ADDENDUM NO. ONE (1)
ILM TERMINAL IMPROVEMENTS
CONTRACT 3

Date: July 12, 2019

RE: ILM Terminal Improvements Contract 3

From: The Wilson Group
PO Box 5510
Charlotte, NC 28299

5 SCHEDULE 1 - SARA PLAN
3/8" = 1'-0"

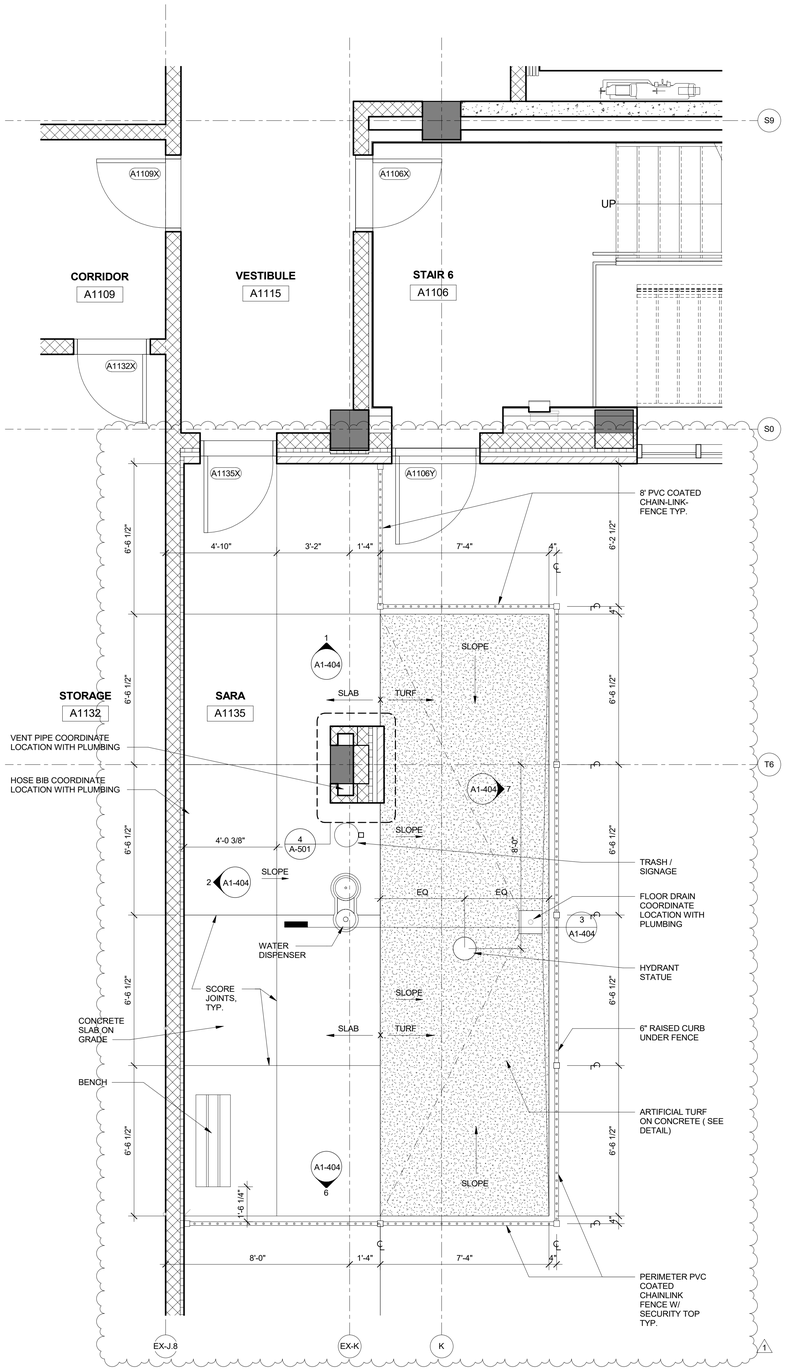
1. QUESTION: On drawing A1-404, can you provide details and specifications for the artificial turf at the SARA? On detail 7, this section does not show up on A1-302. Also, can you provide details of curbing at underside of fence?
ANSWER: See revised drawing included with this Addendum.

5. QUESTION: Where are the SARA bench and SARA fire hydrant statue?

ANSWER: See 5/A1-404.

A2-111

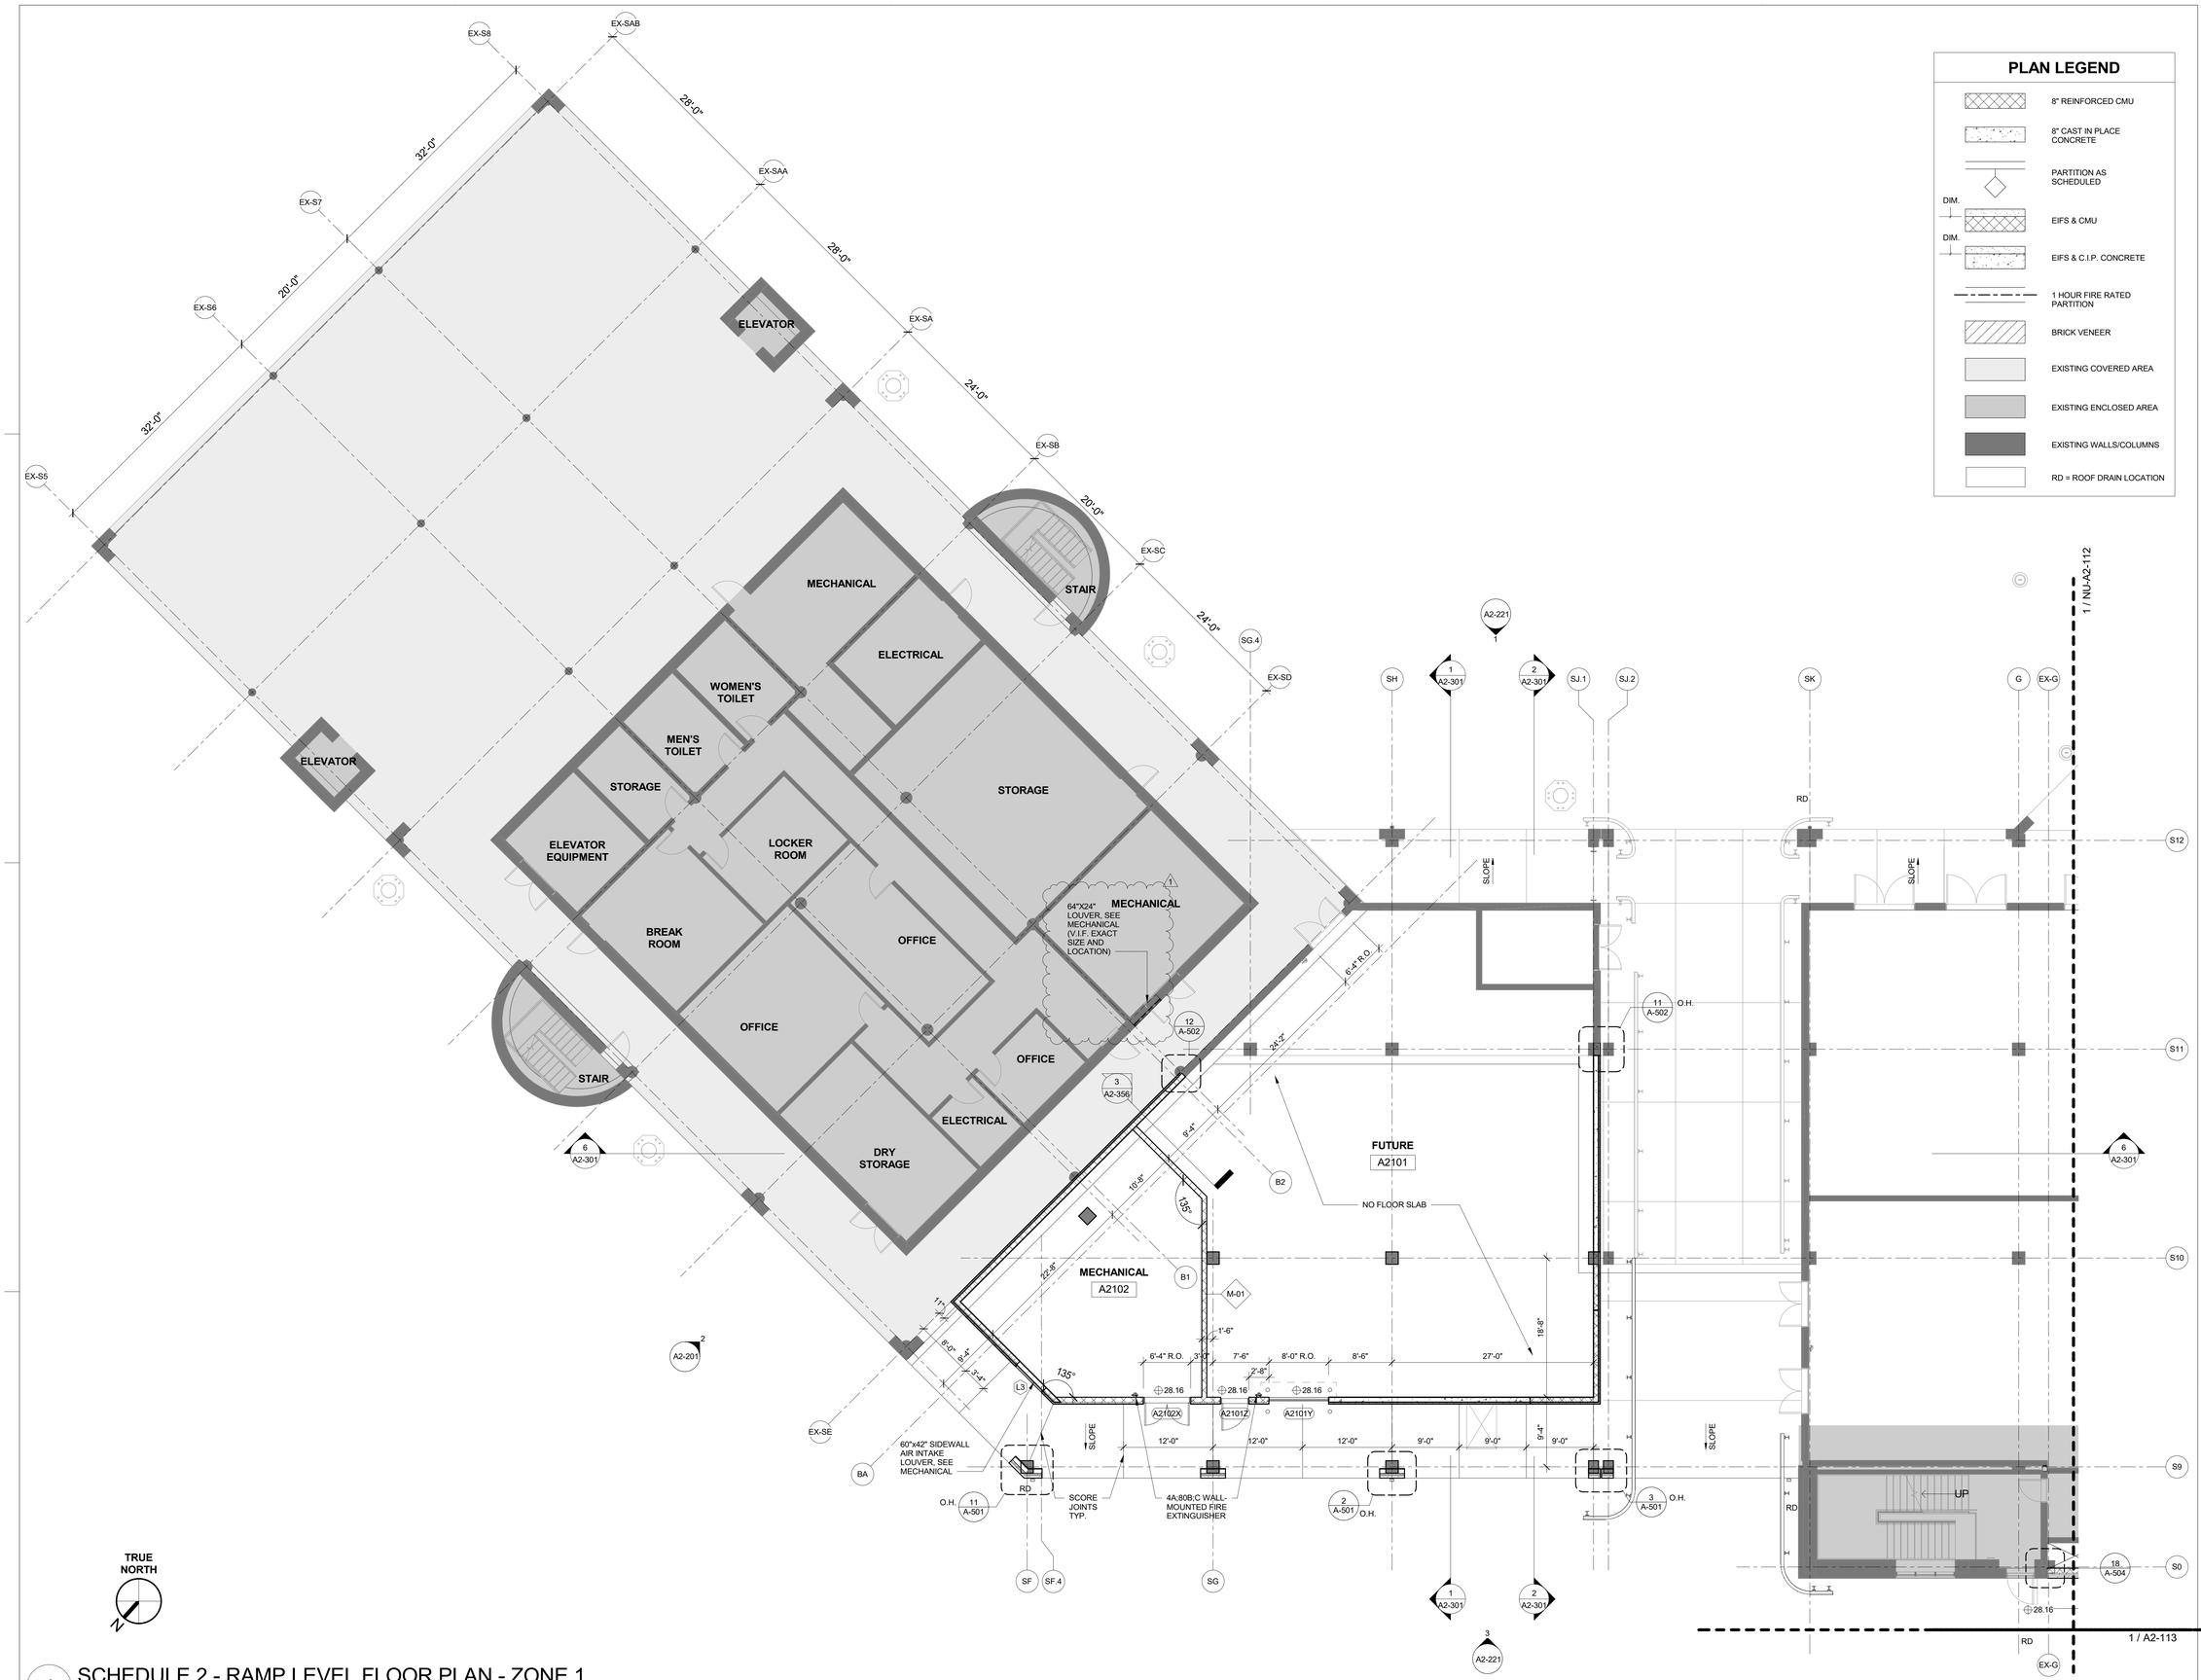
kk. A1-225 – SCHEDULE 1 ENLARGED ELEVATIONS (AD-01). *Note: Showing louvers.*
ll. A1-251 – SCHEDULE 1 INTERIOR ELEVATIONS (AD-01). *Note: Showing TVs & removed data from gate signage.*
mm. A1-252 – SCHEDULE 1 INTERIOR ELEVATIONS (AD-01). *Note: Showing TVs & removed data from gate signage.*
nn. A1-271 – SCHEDULE 1 ENLARGED INTERIOR ELEVATIONS (AD-01). *Note: Showing elevation at signage section – 2 locations.*
oo. A1-402 – SCHEDULE 1 ENLARGED FLOOR PLANS (AD-01)
pp. A1-404 – SCHEDULE 1 ENLARGED SARA PLAN (AD-01) *Note: changed sand bed to cast-in-place concrete, specified artificial turf, provided section showing fence mounting detail, corrected fence type to PVC-coated chain link type.*
qq. A1-421 – SCHEDULE 1 ENLARGED STAIR PLANS (AD-01) *Note: changed fire extinguishers to all be semi-recessed type in cabinet.*
rr. A2-111 – SCHEDULE 2 RAMP LEVEL FLOOR PLAN ZONE 1 (AD-01). *Note: Showing louvers.*

A2-113

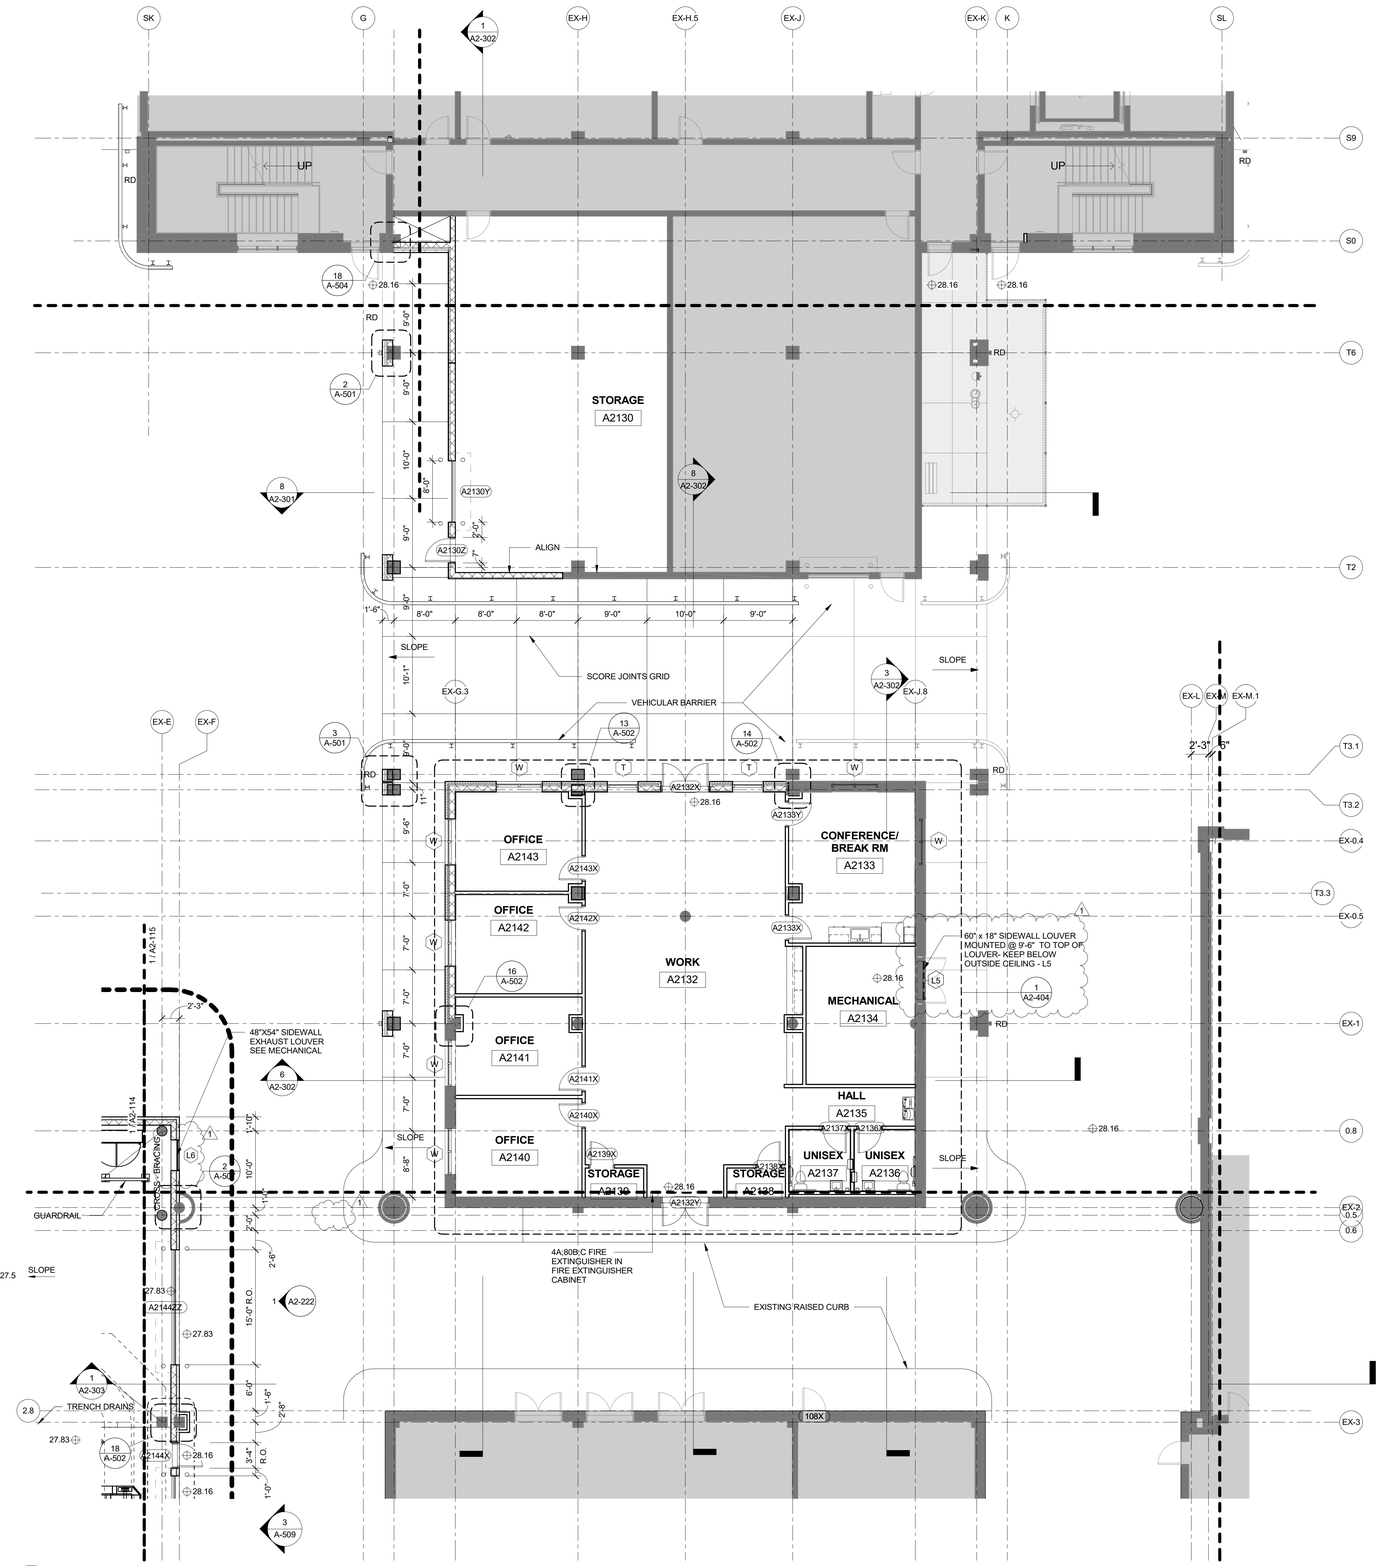
ss. A2-113 – SCHEDULE 2 RAMP LEVEL FLOOR PLAN ZONE 3 (AD-01). *Note: Showing louvers.*
tt. A2-114 – SCHEDULE 2 RAMP LEVEL FLOOR PLAN ZONE 4 (AD-01). *Note: Showing louvers.*

A2-115

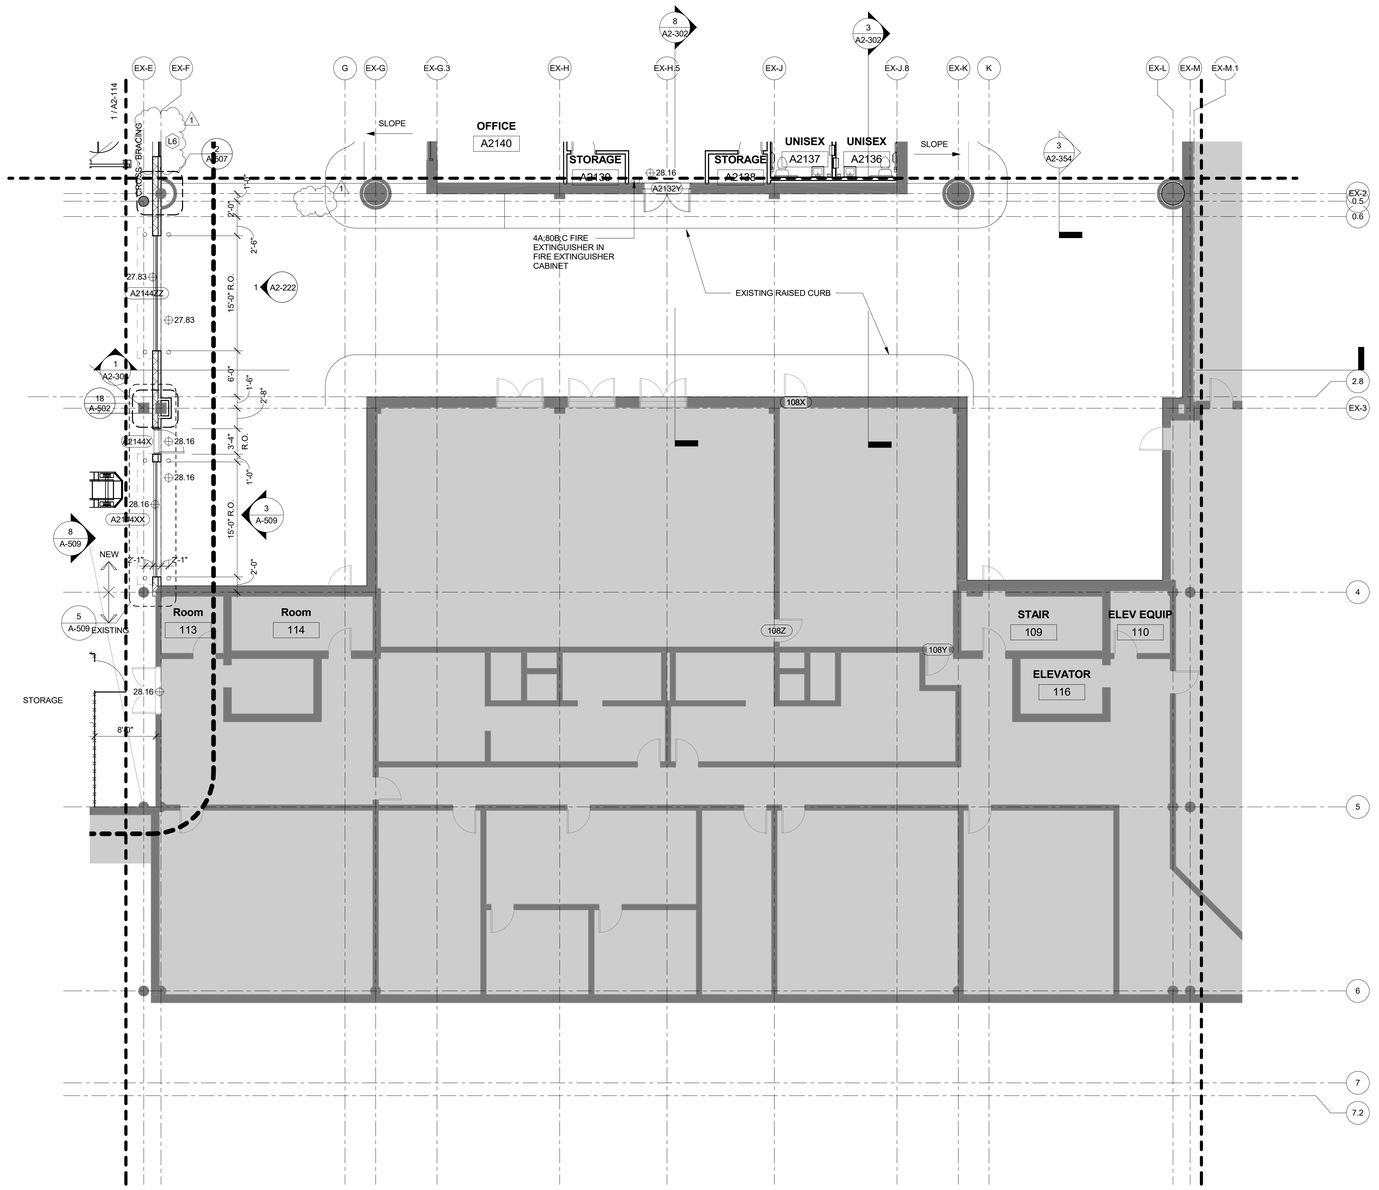
uu. A2-115 – SCHEDULE 2 RAMP LEVEL FLOOR PLAN ZONE 5 (AD-01). *Note: Showing louvers.*
vv. A2-121 – SCHEDULE 2 BOARDING LEVEL FLOOR PLAN ZONE 1 (AD-01). *Note: Modified Gate 2 to incorporate roof drain enclosure.*
ww. A2-143 – SCHEDULE 2 ROOF LEVEL PLAN ZONE 3 (AD-01). *Note: All roof insulation tapered where noted.*
xx. A2-161 – SCHEDULE 2 BOARDING LEVEL RCP ZONE 1 (AD-01). *Note: Modified Gate 2 to incorporate roof drain enclosure.*
yy. A2-201 – SCHEDULE 2 BUILDING ELEVATIONS (AD-01). *Note: Showing louvers and modified window at Gate 2.*
zz. A2-221 – SCHEDULE 2 BUILDING ELEVATIONS (AD-01). *Note: Showing louvers.*
aaa. A2-222 – SCHEDULE 2 BUILDING ELEVATIONS (AD-01). *Note: Showing louvers.*
bbb. A2-251 – SCHEDULE 2 INTERIOR ELEVATIONS (AD-01). *Note: Showing TVs & removed data from gate signage.*
ccc. A2-252 – SCHEDULE 2 INTERIOR ELEVATIONS (AD-01). *Note: Note: Showing louvers.*
ddd. A2-255 – SCHEDULE 2 INTERIOR ELEVATIONS (AD-01). *Note: Note: Showing louvers.*
